REMARKS

Serial No.: 10/711,458

FIG. 6

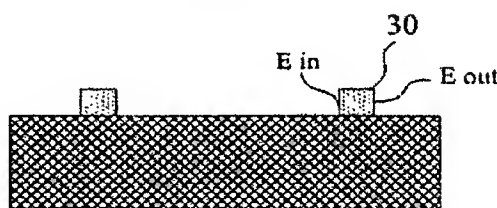
The Examiner is of the opinion that the terms "memorizing" and "loop of sub-lithographic well controlled image size" in claim 1 is vague and indefinite. Applicants do not agree with the Examiner. According to MPEP §2173.02, the test for definiteness under 35 U.S.C. 112, second paragraph, is whether "those skilled in the art would understand what is

Loop Of Sub-Lithographic Well Controlled Image Size

As to the terminology “loop of sub-lithographic well controlled image size”, this is also clearly defined in the specification. For example, paragraph [0030] and FIG. 6 clearly describe and show this feature. Specifically, paragraph [0030] discloses:

[0030] Still referring to FIG. 5, a germanium and oxide etch is then performed to selectively remove the capping layer 20 and the oxide layer 22, respectively. This etching process may be any standard wet chemical etching process or RIE to remove, for example, the Ge layer. One such process may include a solution of hydrogen peroxide to strip the Ge capping layer 20. This etching process results in the structure of FIG. 6; that is, the

nitride layer within the undercut 24 remains on the substrate 12. At this end stage, there is a very well defined loop of nitride, which has a memorized inner edge E_{in} and an outer edge E_{out} . In this manner, the outside edge E_{out} corresponds to the edge of the photoresist 18 and the inner edge E_{in} corresponds to the furthest extent of the undercut, which was previously memorized.

Also, FIG. 6, reproduced below, shows the nitride loop.

In view of the above, Applicants submit that the recitation the “loop of sub-lithographic well controlled image size” is clear and definite when read in light of the specification.
